DA 2019/200 - LATE SUBMISSION RESPONSE

The below presents the proponent's response to three submissions received over the past 3 days in relation to DA 2019/200 for Chatswood Chase Shopping Centre. We appreciate the opportunity to respond to these matters and trust that our position will be considered in the Panel's deliberation on this application.

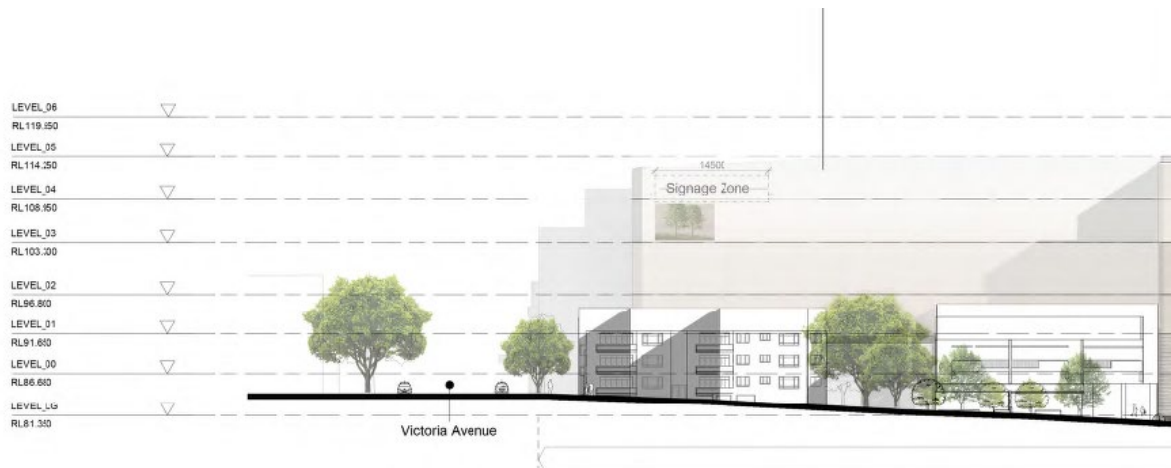
*Signage: There will be a signage zone (9.2*6.495) at the corner of Havilah Street and Victoria Avenue, which seems to be unnecessarily huge. Please kindly consider the harmony of this design with the rest of the neighbourhood. Again, the light from the signage in the evening and at night will be very glaring impacting the residential neighbourhood.*

Due to changes to the façade the proposed signage zone has been reduced in its lateral extent from that approved by DA 2017/503 (14.5m to 9.2m). The content and appearance of the sign, including illumination, is not the subject of this application and therefore that detail will be addressed when a signage proposal is considered by Council in due course.

Comparison Sections

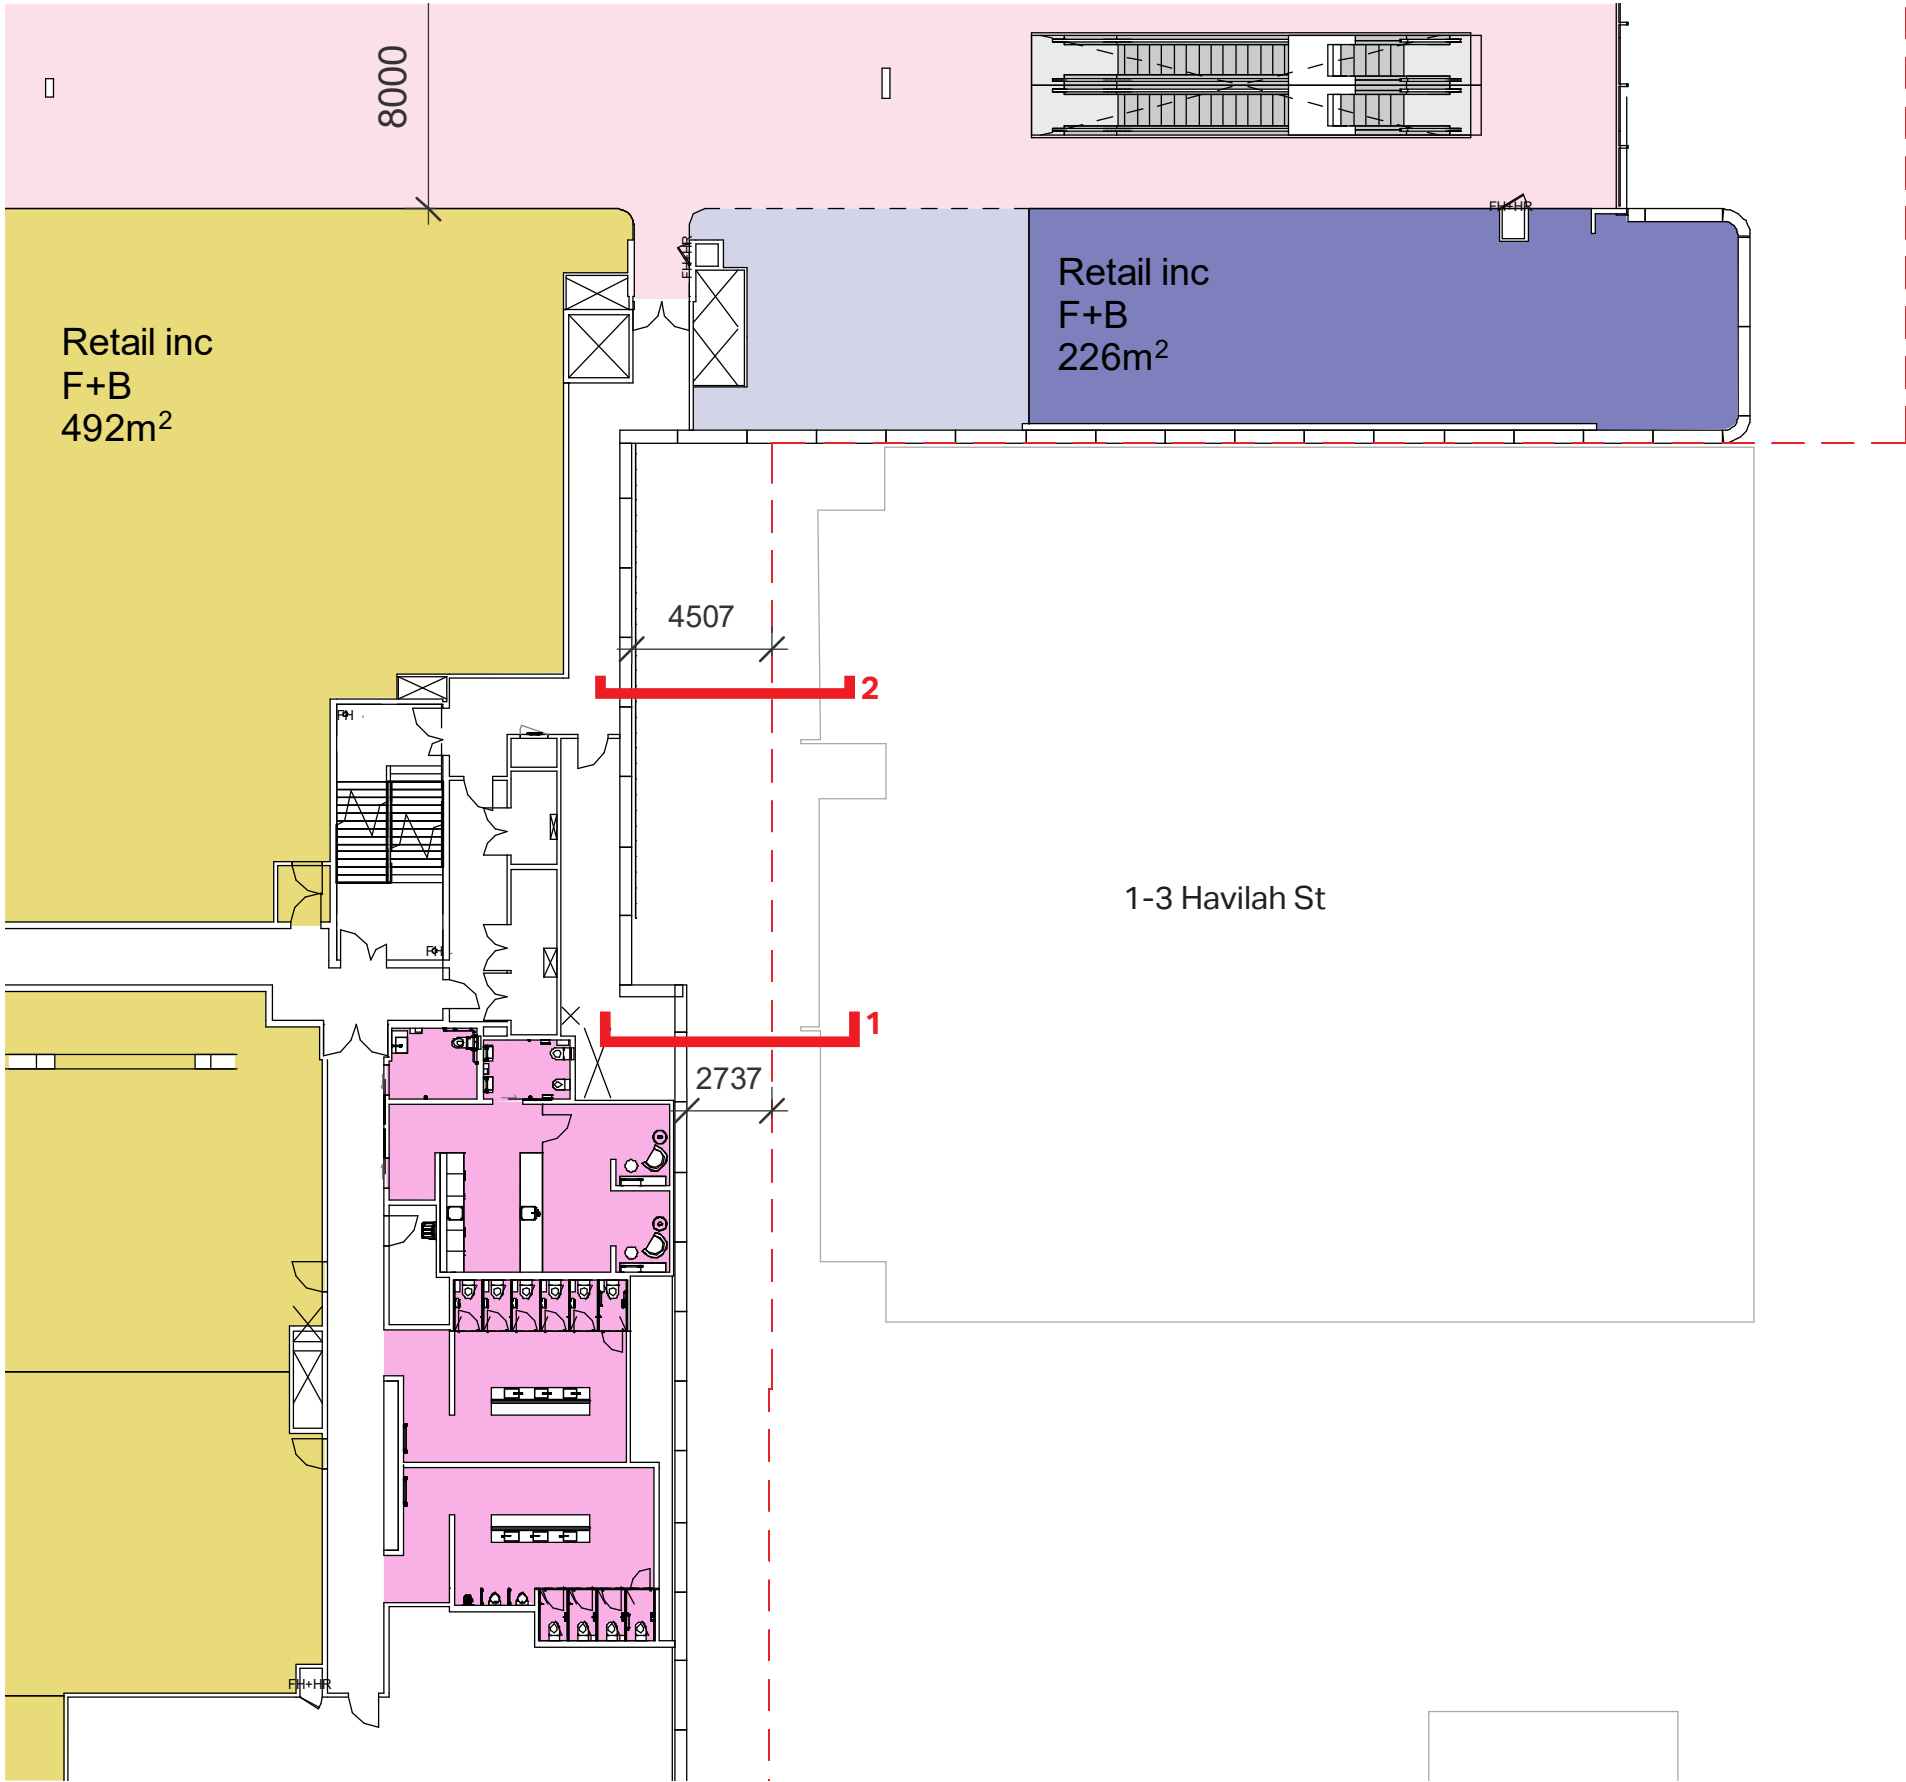
This submission is supplementary to Late Submission no. 1 (above) and seeks the removal of structure at the rear of 1-3 Havilah Street to retain the existing building alignment in that location. The extent of structure sought for removal is shown below.

This late request to alter the design of the building at this location was received 24 hours before the panel meeting, notwithstanding that the application has been through two rounds of public notification. Vicinity cannot commit to a redesign or removal of this extent of building at such a late stage – for reasons relating to structure, services and internal layout.

As noted in response to Late Submission No. 1 (above) the previous consent DA 2017/503 approved a parapet height in this location that is an apparent 9.6m higher than what is now currently proposed. Diagrams produced by the design team show that there will be an increased aperture between the buildings which will result in improved light exposure to the rear of 1-3 Havilah Street than that which has been already approved. Reducing the height of the overall structure provides a demonstrably improved increase in light access to the rear of 1-3 Havilah Street.

If the panel is of the opinion that light access to this space can be improved by the removal of the planter box above the parapet at Level 3 (planter box has current max height of RL 104.5) then Vicinity is happy for this to be removed by condition of consent.
